APPLICATION NO.	FILING DATE	FIRST NAMED INVENTOR	ATTORNEY DOCKET NO.	CONFIRMATION NO.
08/811,152	03/04/1997	YOSHIHARU HIRAKATA	07977/132001	9805

Office Action Summary

DETAILED ACTION

Figure 4A

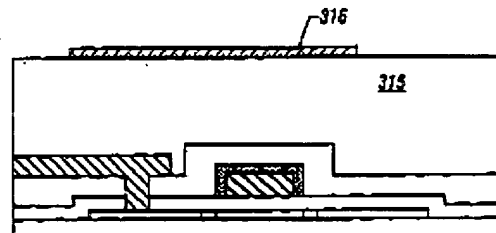
4. Yamazaki discloses and shows in Figs. 3A and 4A-4B, a liquid crystal display device (col. 1, line 6) comprising:

- a second interlayer insulating film (315) (applicant's first interlayer insulating film) comprising an organic resin over the thin film transistor;
 - a common electrode (316) having a function of black matrix over the first insulating film (315);
 - a third interlayer insulating film (317) (applicant's second interlayer insulating film) over the common electrode (316);
 - a pixel line and at least one pixel electrode both formed over the second interlayer insulating film (317), the pixel electrode extending from the pixel line;
 - a liquid crystal layer over the pixel line and the pixel electrode;
- wherein the pixel electrode is electrically connected to the thin film transistor through the pixel line; and
- a storage capacitor (319) formed between the pixel line and the black matrix.

Yamazaki differs from the claimed invention because Yamazaki does not explicitly disclose that the liquid crystal display device is an in-plane switching type device, i.e., the liquid crystal layer being driven by an electric field formed between the pixel electrode and the common electrode, the electric field having a component parallel with the substrate.

Figure 4B

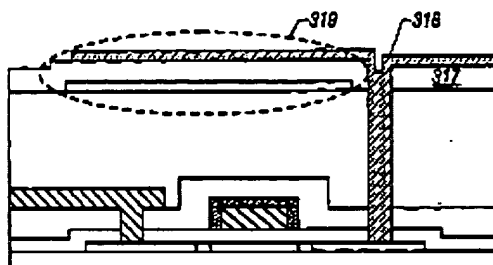
As to claims 145, 152 and 159, it is clear from figure 4B of Yamazaki that the second interlayer insulating film (315) (applicant's first interlayer insulating film) exhibits excellent flatness and thus serves as a planarization film.

6. Yamazaki discloses a liquid crystal display device comprising a thin film transistor connected with the pixel electrode and having, as an active layer, a semiconductor layer. See Fig. 4B.

As to claim 165, it is clear from figure 4B of Yamazaki that the second interlayer insulating film (315) (applicant's first interlayer insulating film) exhibits excellent flatness and thus serves as a planarization film.

10. Yamazaki discloses a liquid crystal display device comprising a thin film transistor connected with the pixel electrode and having, as an active layer, a semiconductor layer. See Fig. 4B.
